Report: TAB Report
Function: Test, Adjust, & Balance
Date: 12/12/2025
Completed By: National TAB

PROJECT
02-02-26 QT #1176 CAYCE, SC

Project: 02-02-26 QT #1176 CAYCE, SC

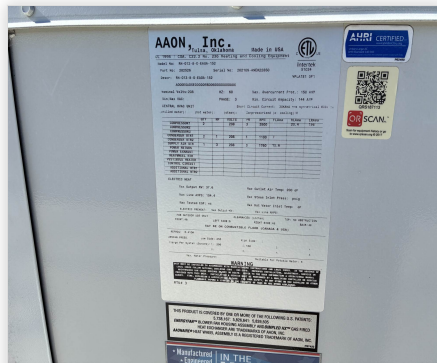
Issue Name : No Hood End Panels Installed
Description : There are no hood end panels installed as per the Hood Schedule.
Created By : National TAB **Assigned To :** National TAB - Dan Hertenstein
Status : Open
Priority : Low **Asset Tag :** HD1
Originated Date : 02/03/2026 - Alex Bauer - National TAB

Asset: RT-4

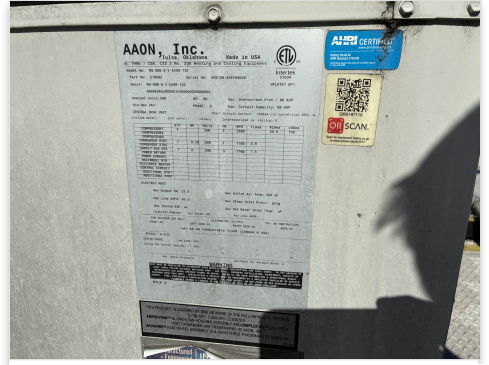
[1] BELOW SCHEDULED AIRFLOW. UNIT IS 6 TONS AND OPERATING AT 371 CFM PER TON. NOT ANTICIPATED TO CAUSE ANY ISSUE.

Asset: EF1

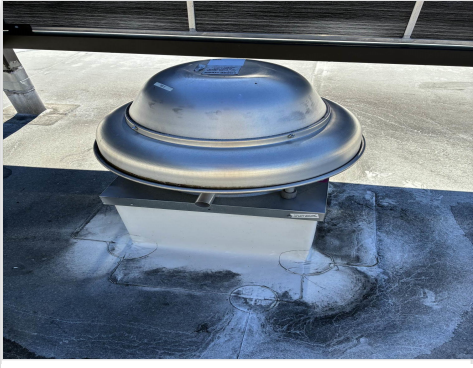
Notes:
[1] NO DAMPER INSTALLED ON COMBI-OVEN GRILLE. UNABLE TO REDUCE.

Asset: HD1

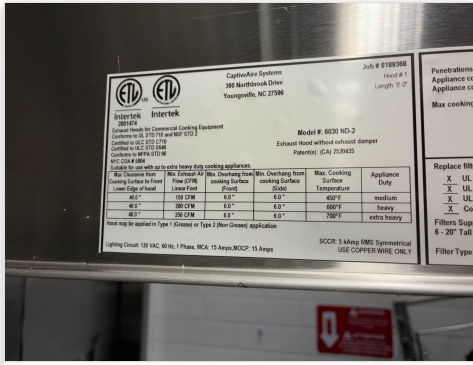
End panels are installed per prototype? Fail
